CRYSTAL SPRING WATER TREATMENT PLANT
CLEARWELL REPLACEMENT
WESTERN VIRGINIA WATER AUTHORITY
CITY OF ROANOKE, VIRGINIA

CH2MHILL®
ELECTRICAL
LOW LIFT AND HIGH ZONE PUMP STATION
DIAGRAMS

DATE: JUNE 2014
PROJ: 475481
DWG: E-8001
SHEET: 32 of 37

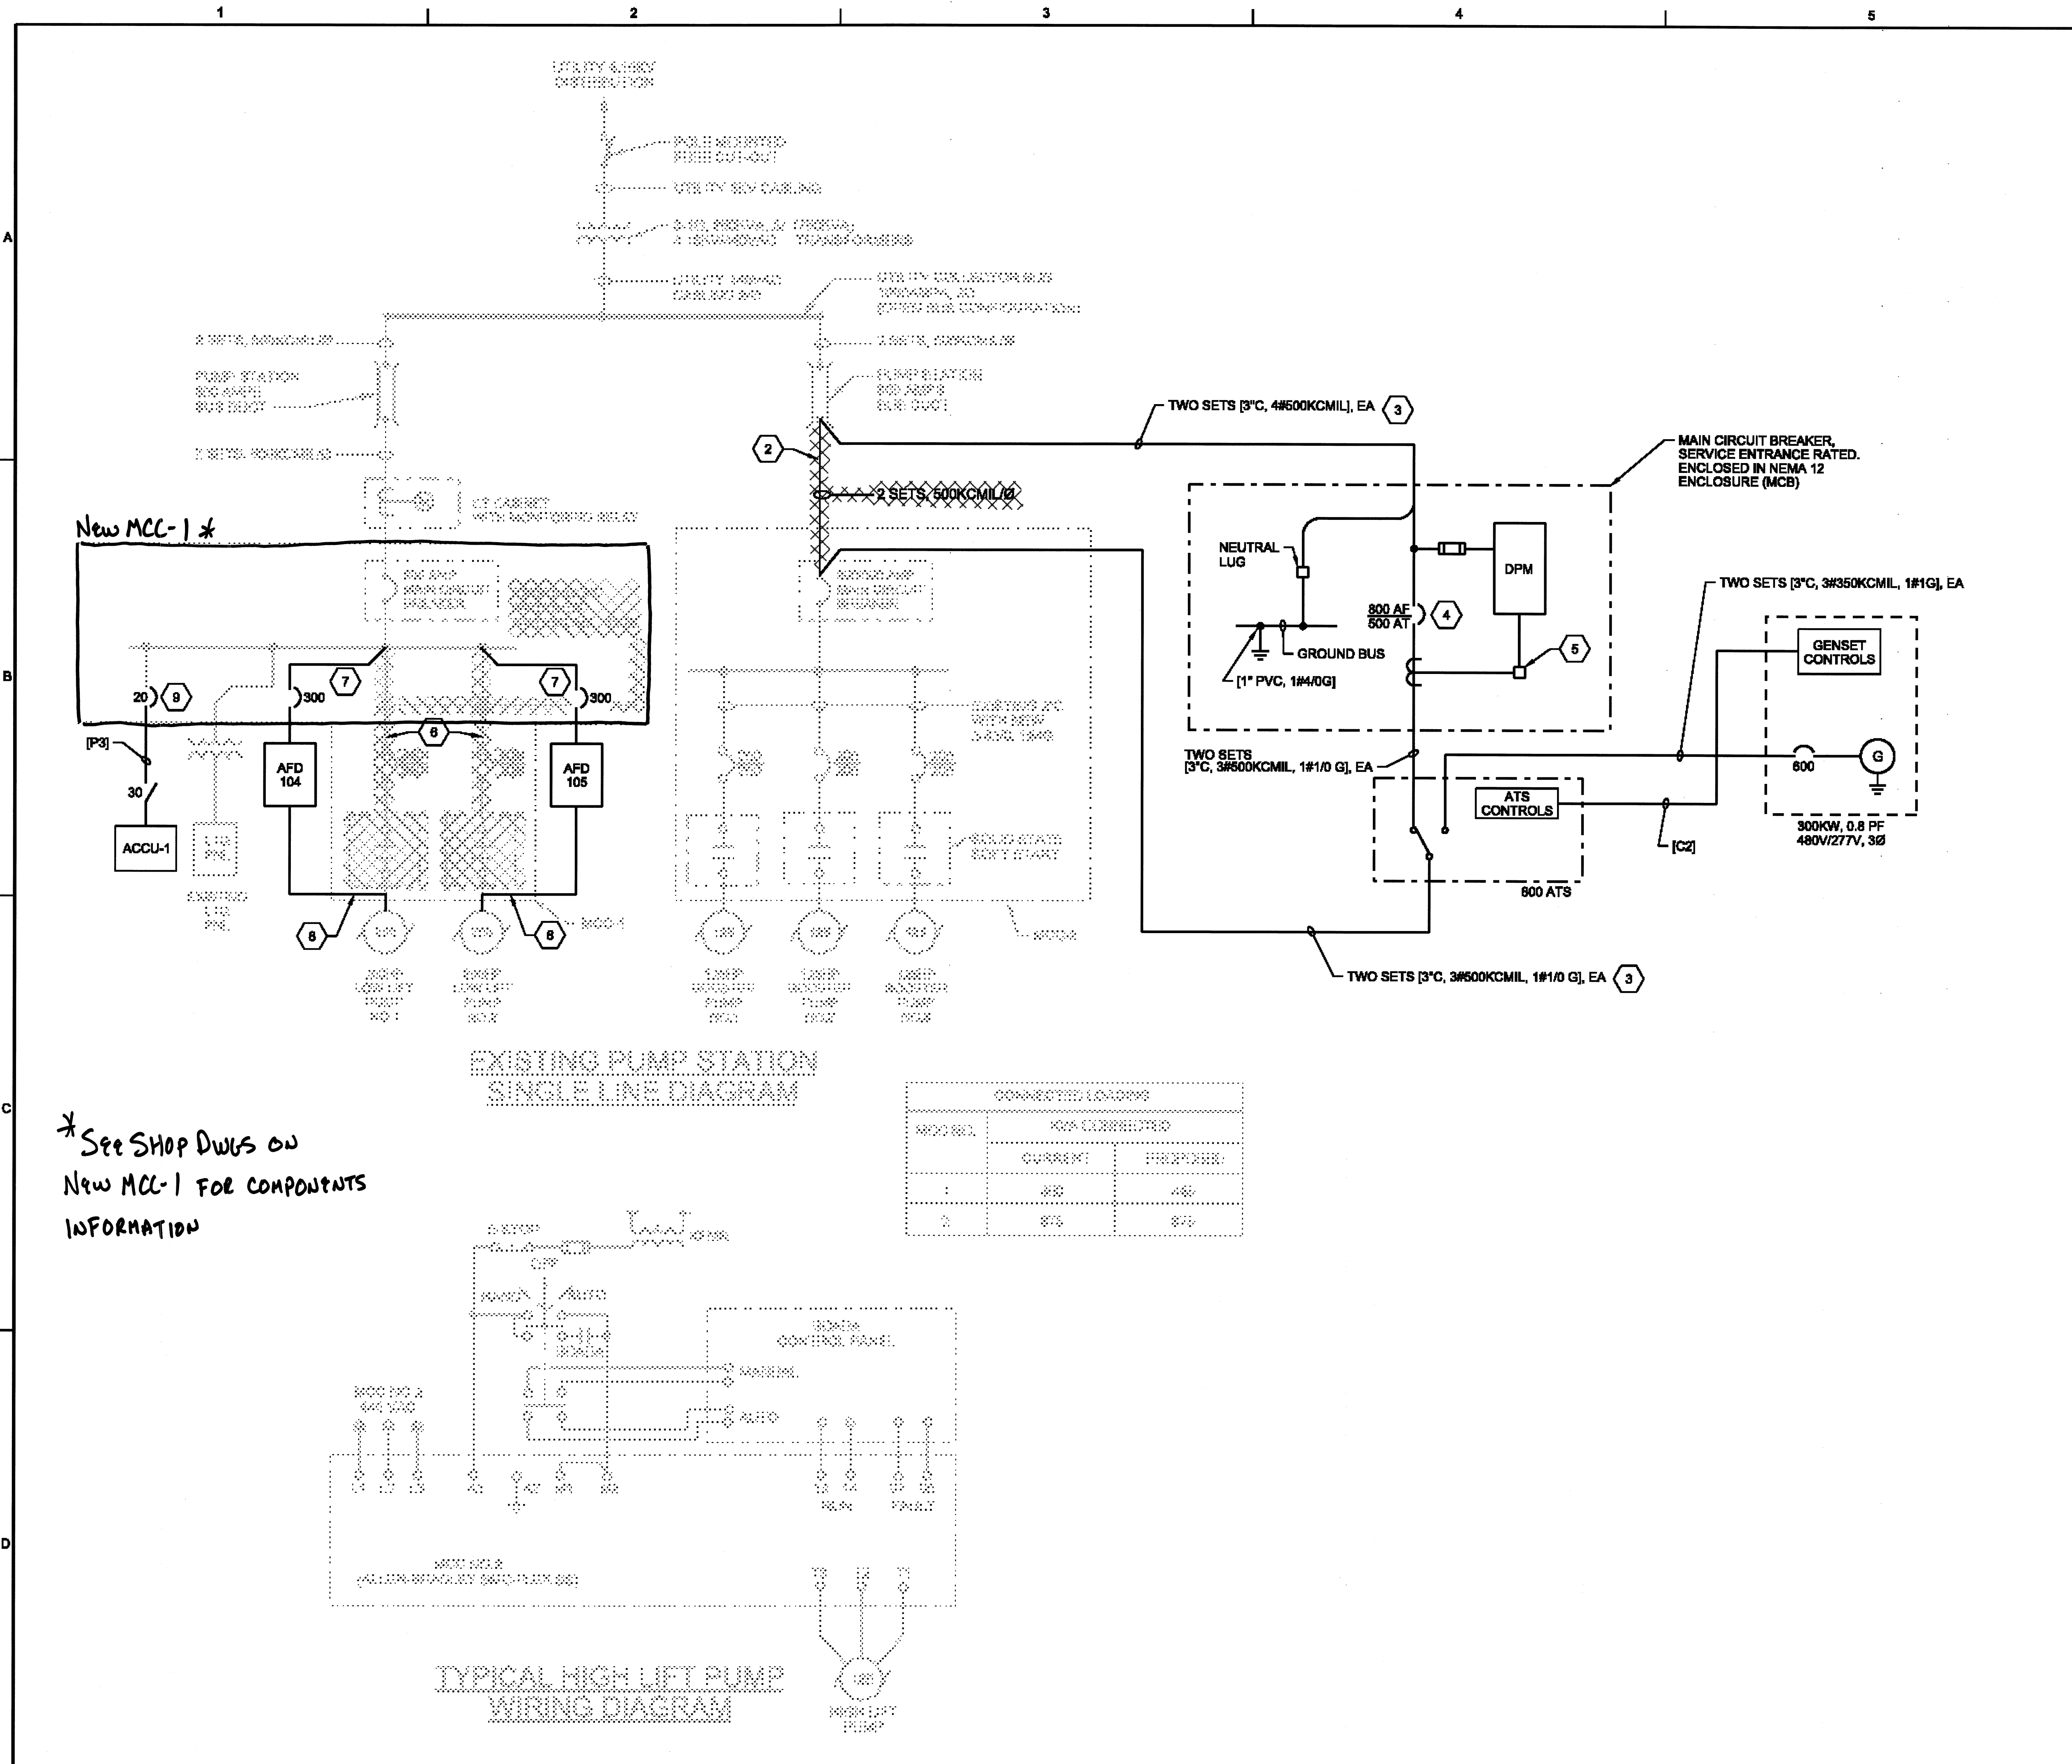
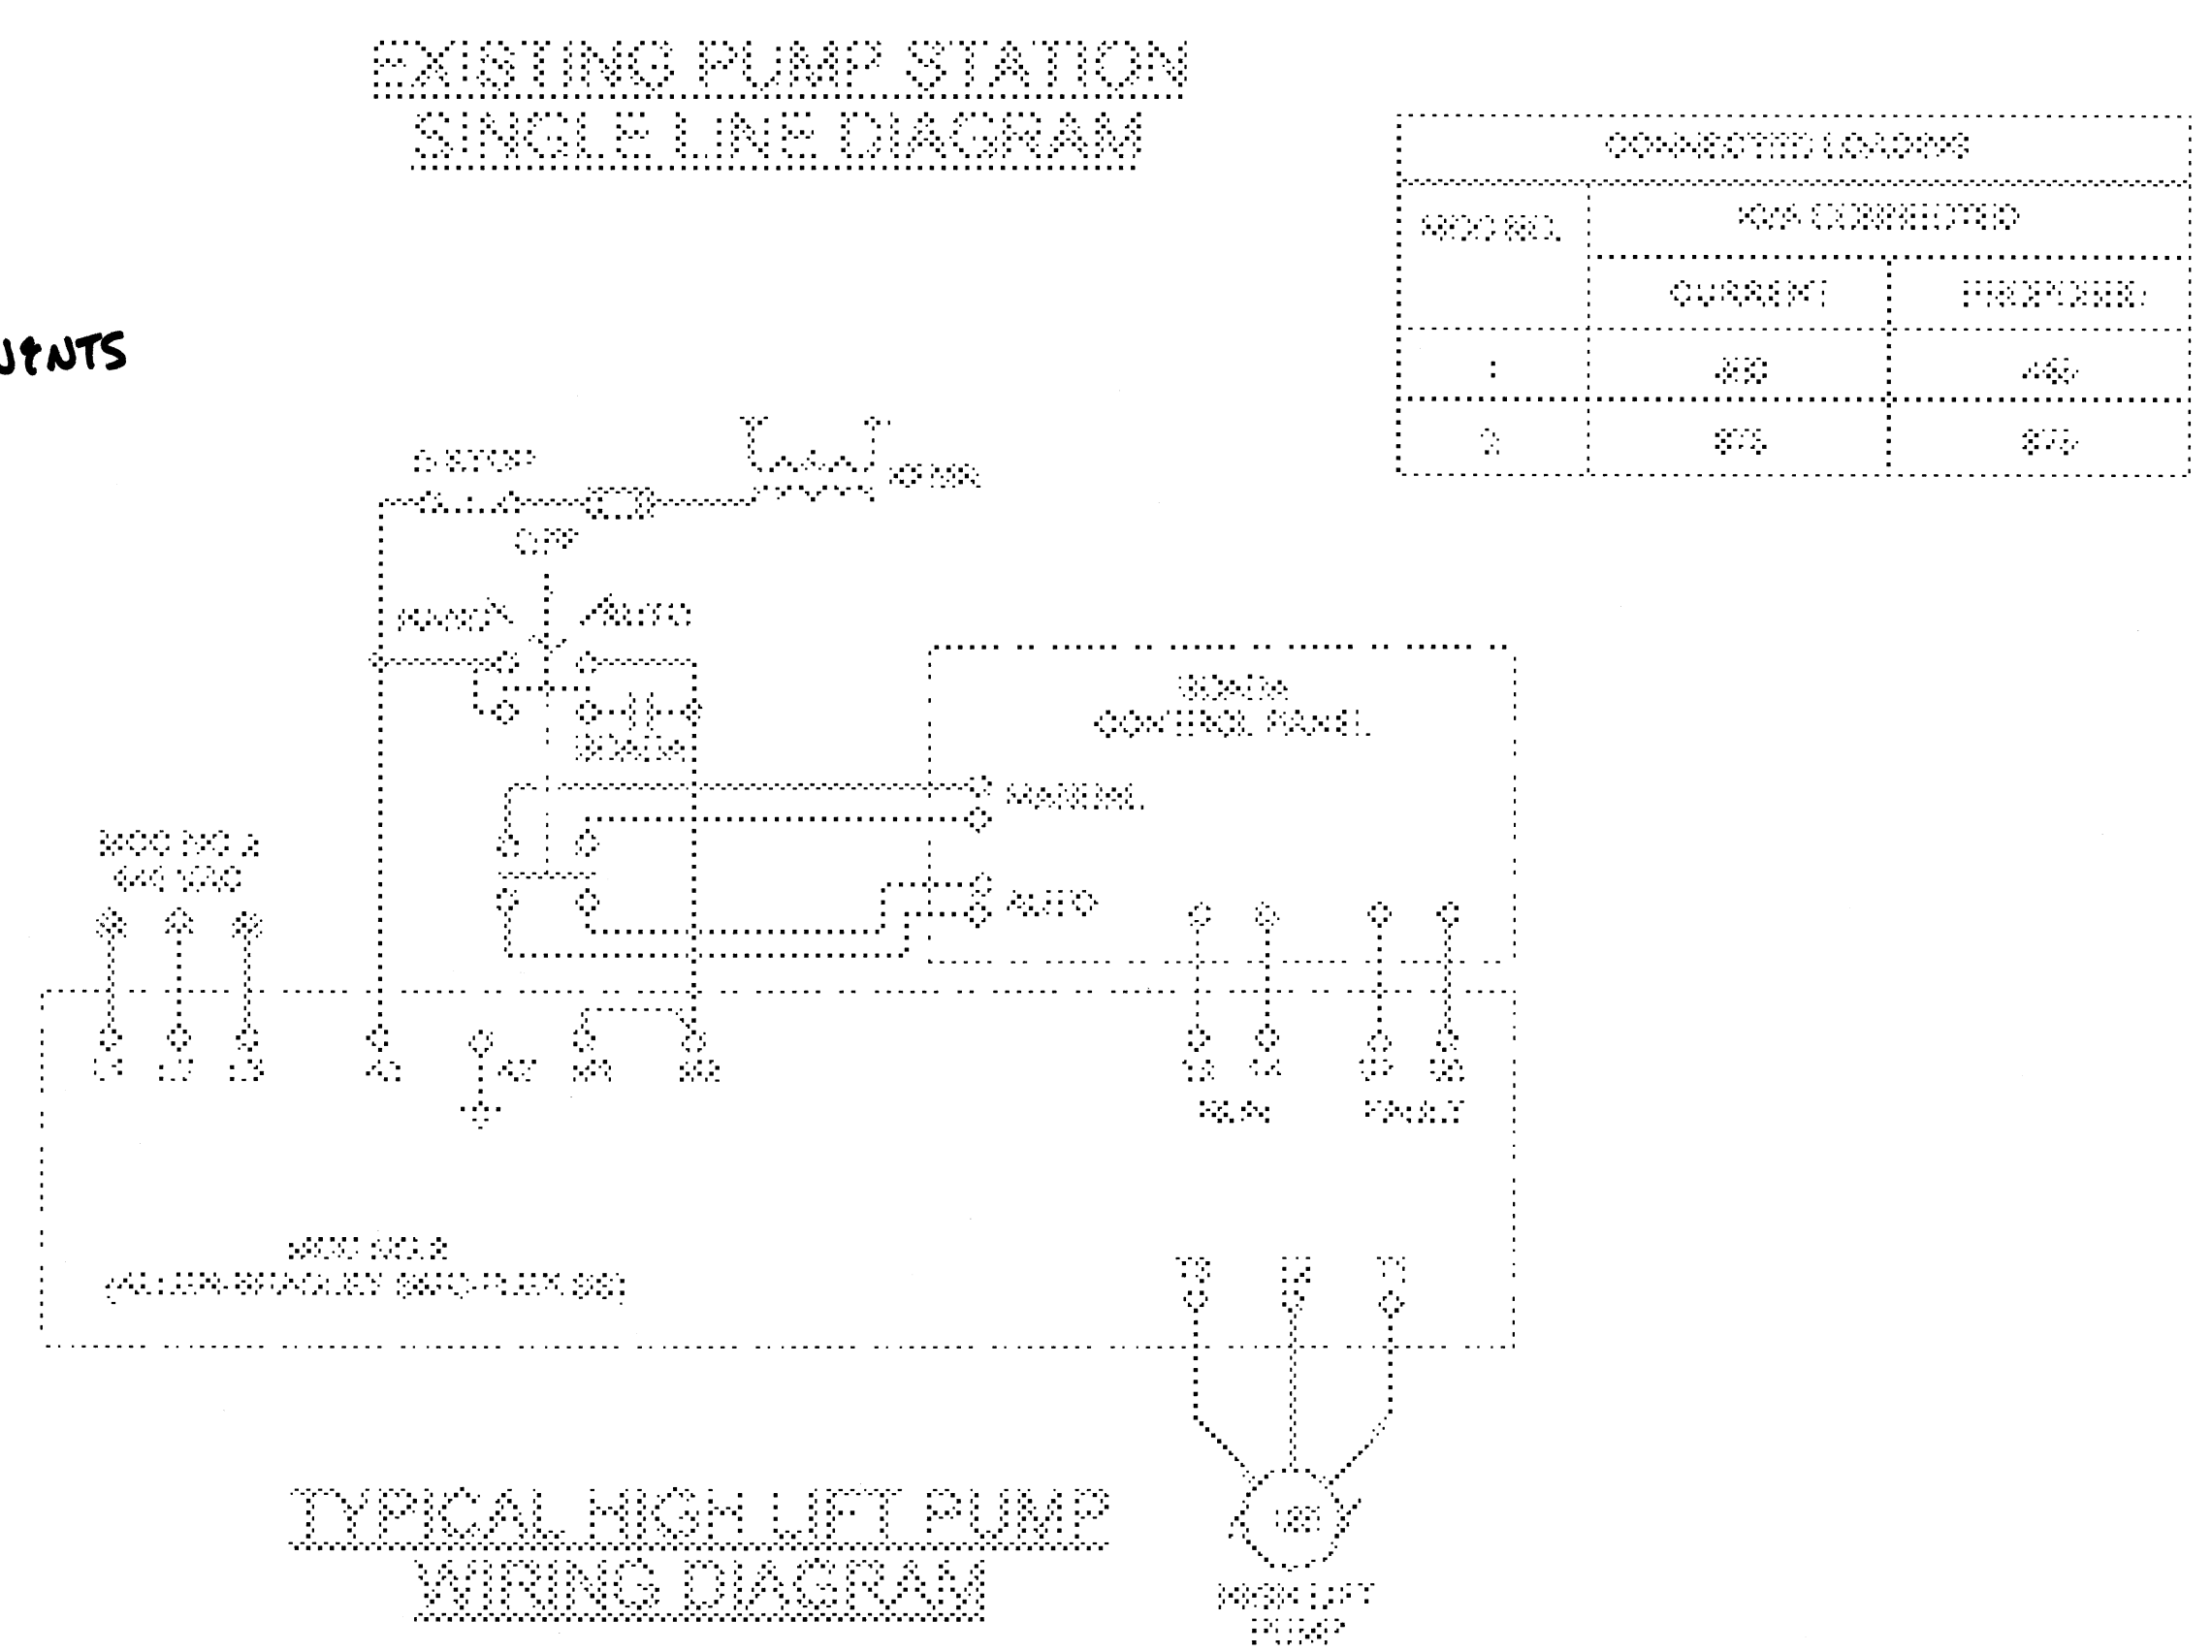
* See SHOP DWGS ON
New MCC-1 FOR COMPONENTS
INFORMATION
